Technical Review of Sio Silica Corporation's Environment Act Project Proposal

Vivian Sand Extraction Project

13 September 2022

Figure 4 Project Spatial Scope (1 of 2)

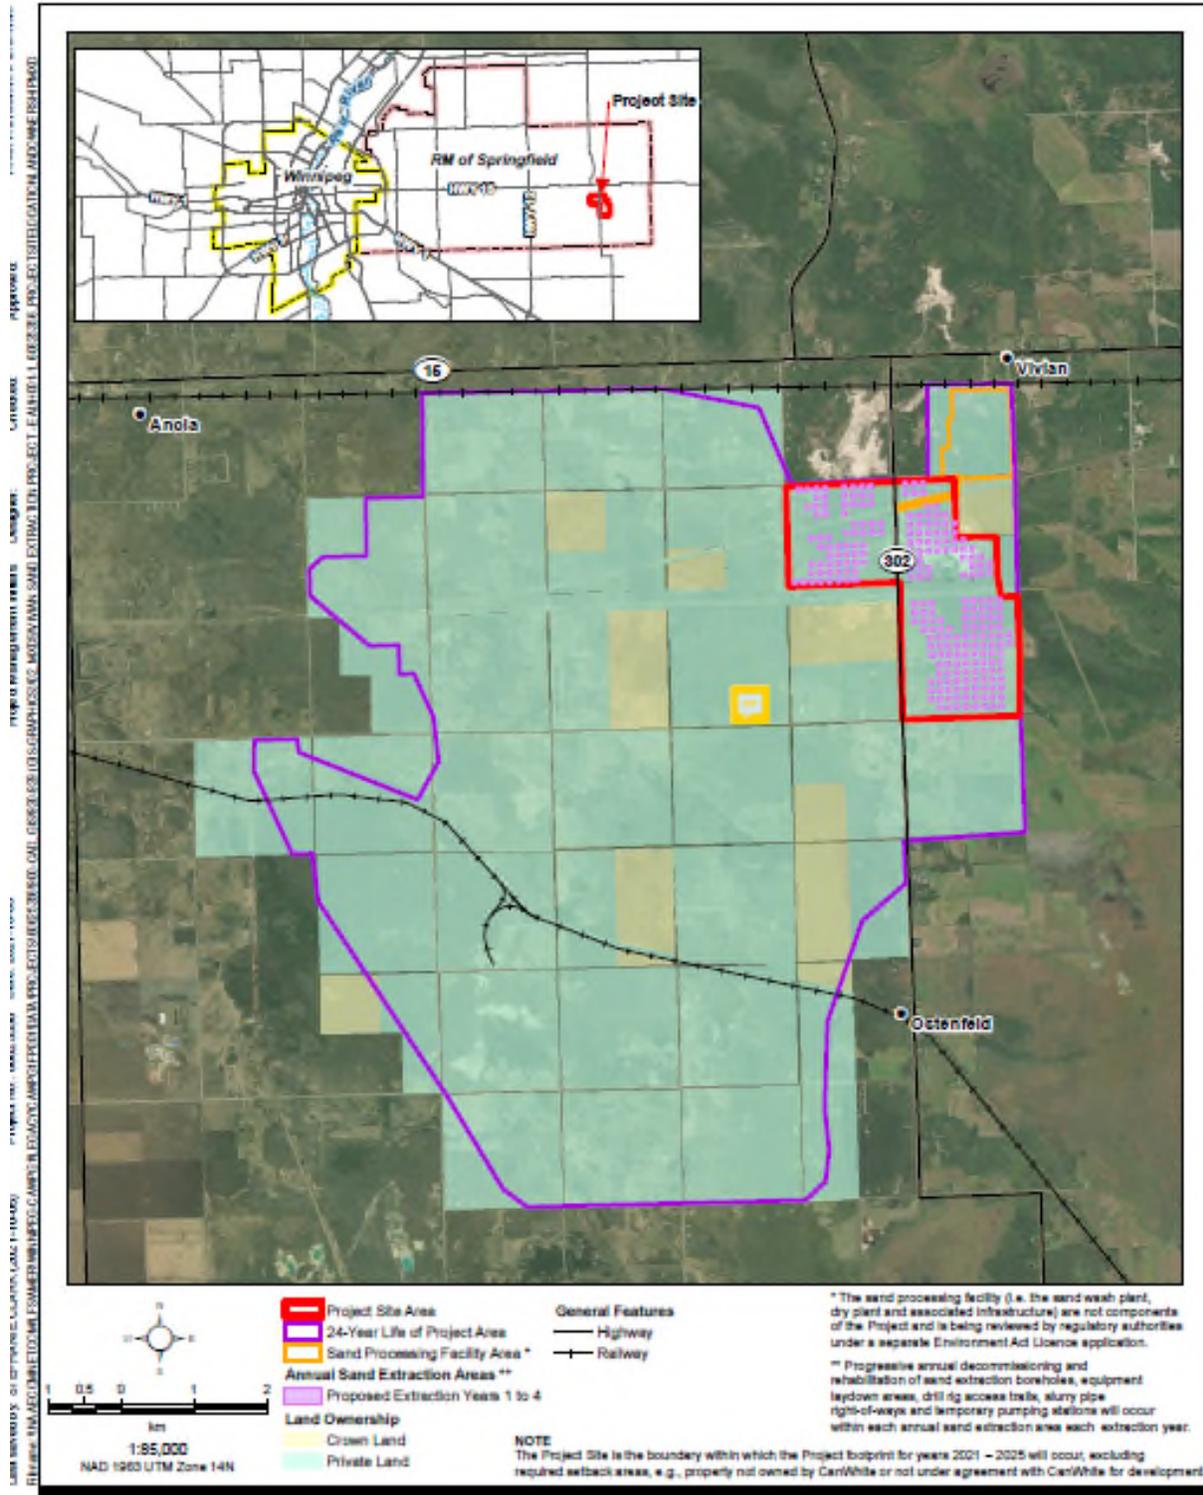
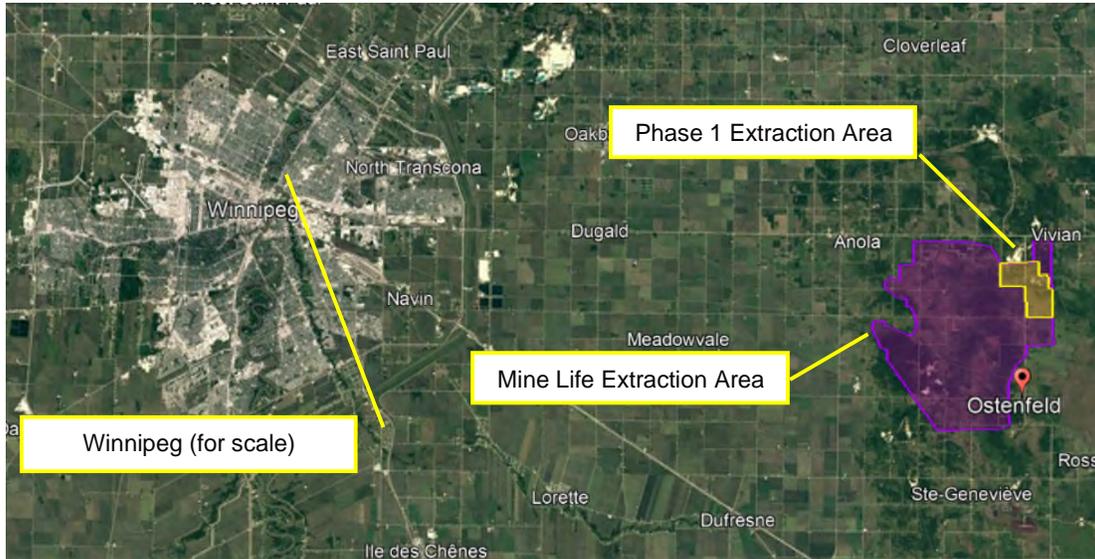
The conceptual progression of well development and extraction during the initial four-year phase and subsequent years of operation are illustrated in Figures 4 and 5. Based on those figures, it is evident that the spatial scope of development assessed by the Proponent in the current Project Proposal represents a small portion of the area that will ultimately be impacted during the 24-year mine life. In this regard, the Proponent's decision to substantively limit the temporal scope of the Project Proposal has also resulted in the spatial scope of the assessment being limited.

The mine has an expected life of 24 years but only 4 years of mining activity have been assessed in the Project Proposal. While breaking projects into phases is a common approach when issuing regulatory authorizations, it is

inappropriate in the context of Environmental Assessment because it has the potential to underestimate the spatial extent, duration and therefore significance of project impacts.

Figure 6 Bending Failure Mode in Bedded Limestone

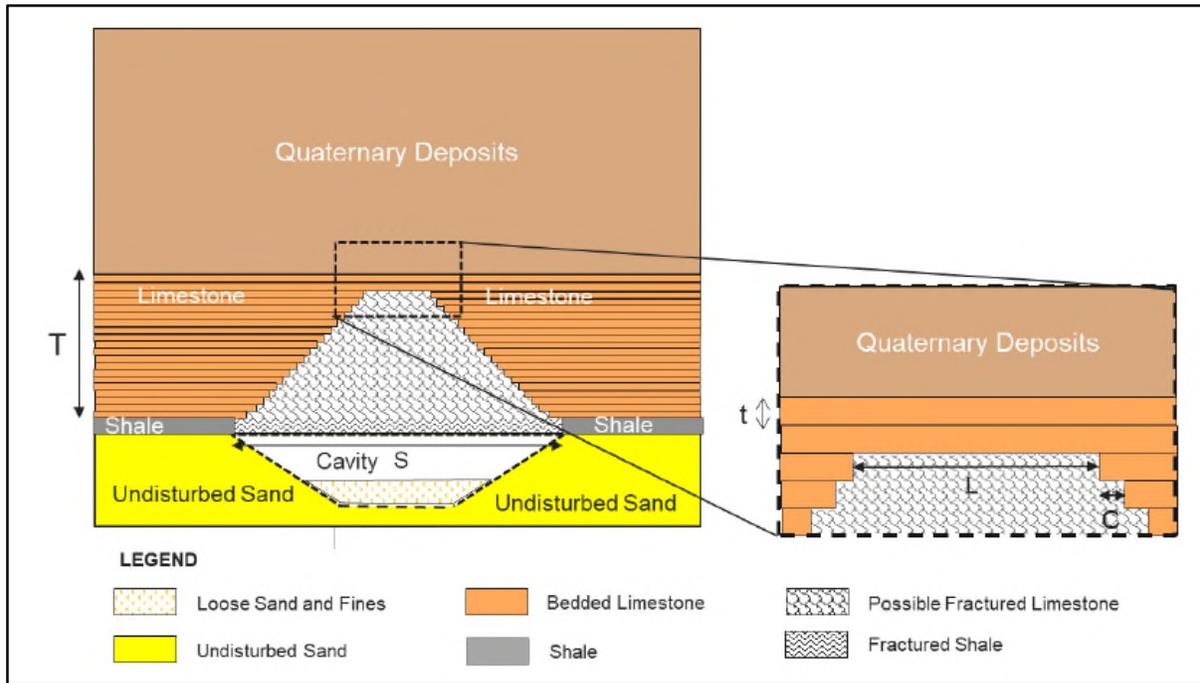
Notwithstanding the conclusions presented above with respect to potential surface impacts, Arcadis notes that the failure modes evaluated by Stantec (2022) do not assess the geotechnical fate of the shale aquitard between the limestone carbonate and sandstone aquifers (see Figure 6). The Stantec report does, however, indicate that the
